Reference: Docket No. CP07-208-000

I would like to add an addendum to the document that I posted via e-link on 1-29-08 (this will be my fourth posting).

Sharptown Rd area New Developments: Historical Site issue from DNR & MP402  
"constructability issues"

FIGURE ONE

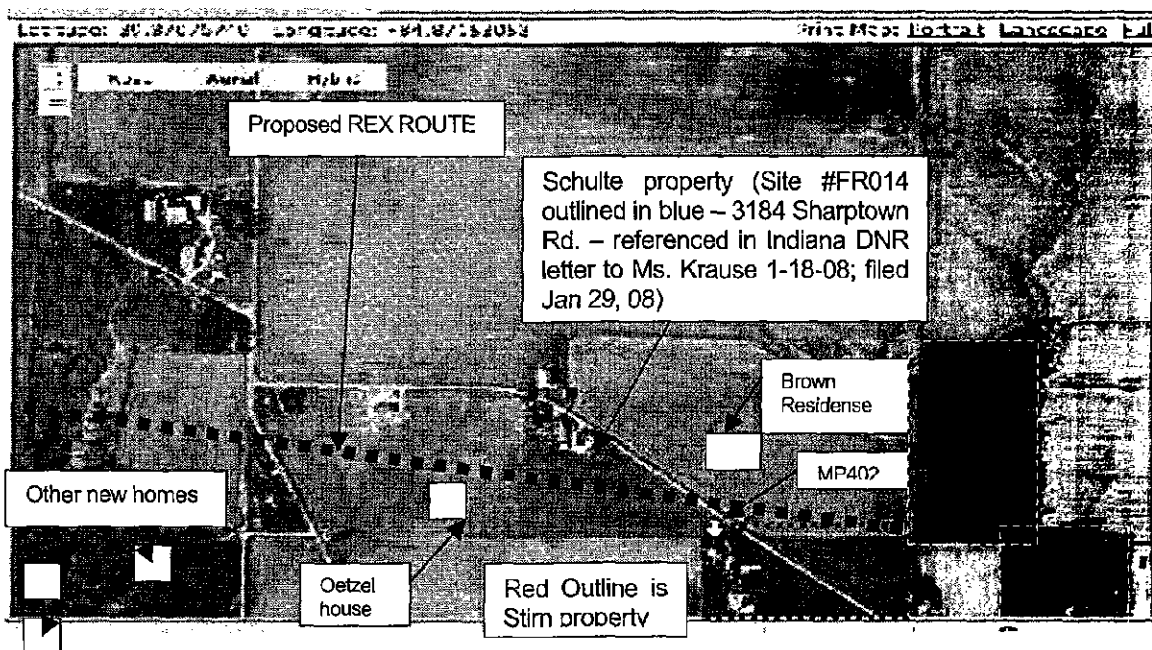
I also am interested in REX's response to FERC's request to identify "constructability" issues specifically in the MP 401.5 to 402 area (Schulte and Oetzel property – ref item 23 in Feb. 8<sup>th</sup>, 2008 letter to Ms Weekly from Ms. Alisa Lykens in Gas Branch 2). As identified in my prior docket postings on 1-14-08, 1-21-08 and 1-29-08, our property is adjacent to this area. See Figure One below in RED:

FIGURE THREE

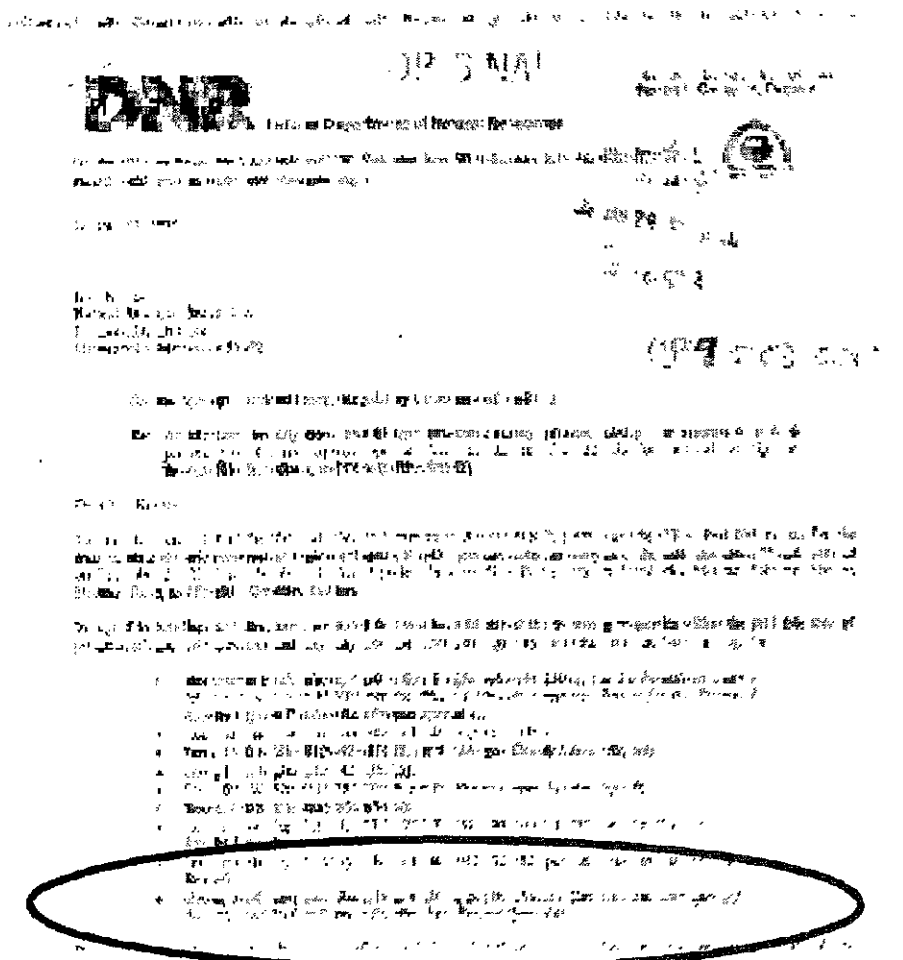
Since these postings were filed (last one 1-29-08), the letter from Indiana Department of Natural Resources Mr. James A. Glass, PhD, Deputy State Historic Preservation Officer (dated 1-17-08 and filed 1-29-08 in FERC) has referenced a concern about House, 3184 Sharptown Road (Site #FR014, per the Phase I Historic Structures Survey for the Proposed Rockies Express Pipeline East Project-Spread 4-FIGURE THREE BELOW).

As you can see, this is a new and significant reason to move the pipeline from this congested area.

FIGURE FOUR (NOTE WELL LOCATION IN GREEN and Historical Landmark)

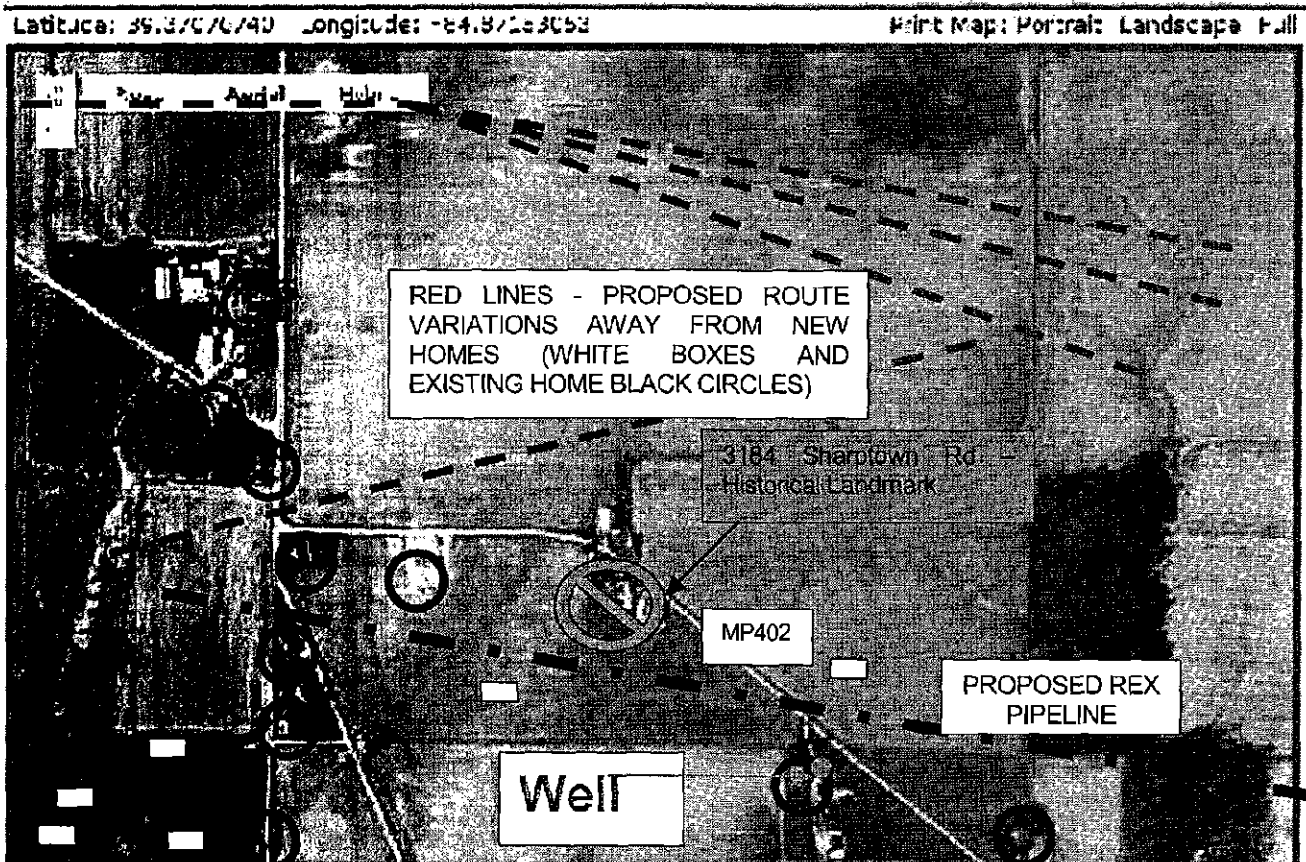
- 1) INDY NORTH ROUTE THROUGH EXISTING EASEMENT CORRIDOR. THIS IS MENTIONED IN DRAFT ENVIRONMENTAL IMPACT STUDY (DEIS).
- 2) ROUTE NORTH OF BROOKVILLE RESERVOIR. THE POPULATION NORTH OF BROOKVILLE IS MUCH LESS POPULATED AND TOPOGRAPHY IS MUCH FLATTER AND WOULD BE AN EASIER ROUTE FOR CONSTRUCTION PURPOSES. REX WOULD PROBABLY SAVE MONEY, ESPECIALLY SINCE THE WHITEWATER RIVER WOULDN'T HAVE TO BE CROSSED AND IT WOULD NOT BE NEAR 3 MAJOR LOCAL WATER SUPPLIERS/COMPANIES.
- 3) ROUTE NORTH OF SHARPTOWN ROAD. SEE FIGURE FOUR BELOW. THIS ROUTE ELEVATES THE CONGESTION IN THE AREA AND LESSENS THE IMPACT TO A FEWER NUMBER OF LANDOWNERS WITH **EXISTING HOMES** AND PROPERTY VALUES. CURRENTLY THE LAND NORTH OF SHARPTOWN ROAD AND SOUTH OF SPARKS ROAD HAS NO HOMES. IT ALSO IS FAR ENOUGH FROM OUR WELL TO ALLEVIATE ANY WATER QUALITY ISSUE.

Proposed route variation with aerial view (note new housing added since aerial photo taken)
